Response to Anonymous Referee #2

**Summary/General comments:** Wolfe et al. describe the CARAFE aircraft, payload, and measurement methodology including flight data from campaigns in 2016 and 2017. Much of the manuscript focuses on the airborne eddy covariance method, how it is applied, and uncertainty analysis. The manuscript is well written and well placed in AMT. The authors have done a commendable job attempting to investigate the many challenges and sources of uncertainty in performing airborne eddy covariance. I do have some reservations and questions that need to be addressed. Once appropriate changes are made I would recommend publication.

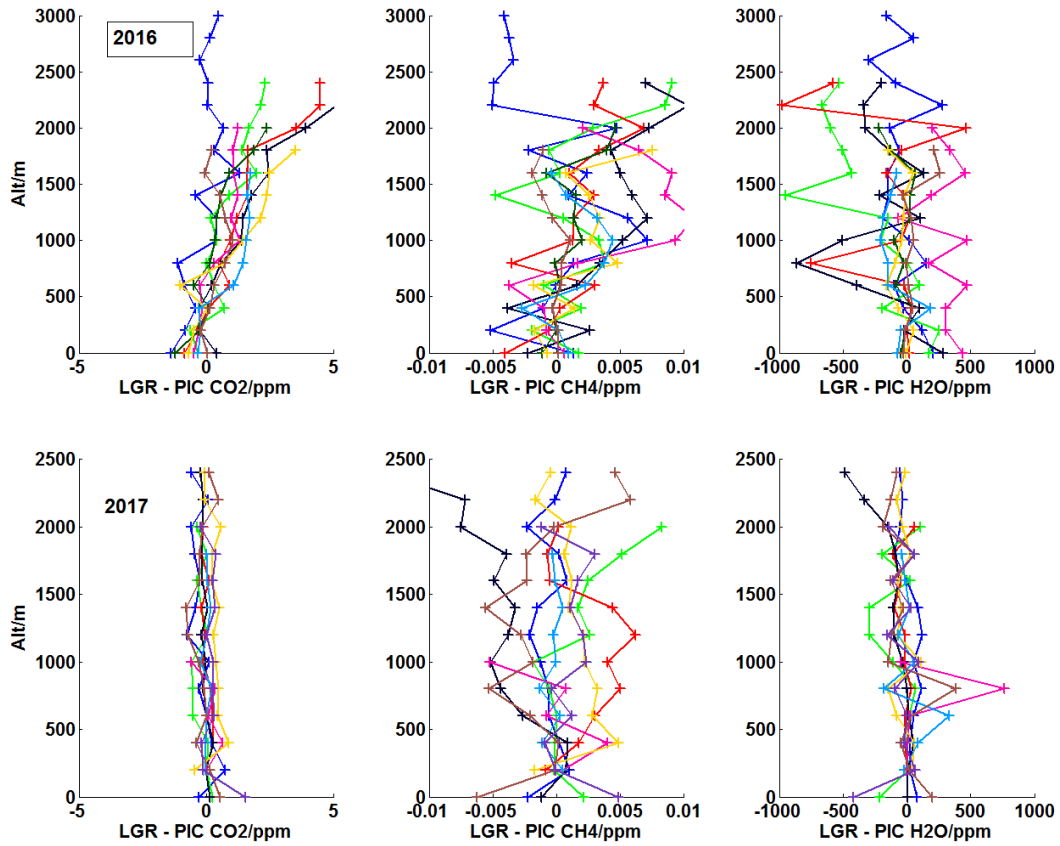
**Section 2.4: I need to see more on the in-flight performance of the GHG analyzers. What is the accuracy in flight? Can the authors show the LGR analyzers show no vertical dependency compared with the Picarro?**

We do not currently calibrate the GHG system in-flight. Chen. et al. (2010) have demonstrated the stability of the Picarro G1301-m under flight conditions and suggest that ground-only calibrations are sufficient to obtain an accuracy of 0.05 ppm for CO<sub>2</sub>. Karion et al. (2013) suggest a total uncertainty (including precision and other error terms) of 0.23 ppm for CO<sub>2</sub> and 2.3 ppb for CH<sub>4</sub> from another airborne G1301-m system operating over a broader range of altitudes than those covered by CARAFE. Based on these values and considering that we do not calibrate in-flight, we have revised our accuracy estimates in Table 1 to be more conservative.

The LGR is necessarily less accurate than the Picarro because of our fitting procedure, by roughly a factor of 3-4 based on comparisons between the final 1 Hz data products. This information is included in our data files but was accidentally omitted in Table 1, and we have added it now.

High accuracy is not critical for airborne EC, as evidenced by our error discussion; accuracy is generally a small term in the total flux error budget (Fig. 7). Indeed, in the case of CO<sub>2</sub> and CH<sub>4</sub>, the accuracy error is dominated by the 5% winds uncertainty.

As shown in the plots below (colored lines denote different flights), there is some vertical dependence in the difference between the LGR and Picarro for CO<sub>2</sub> measurements in 2016, the reasons for which are unclear at this time (possibly improved pressure control). The bulk of surface flux observations

come from measurements below 500 m, where the difference is generally within our stated uncertainty. This issue has little bearing on derived fluxes.
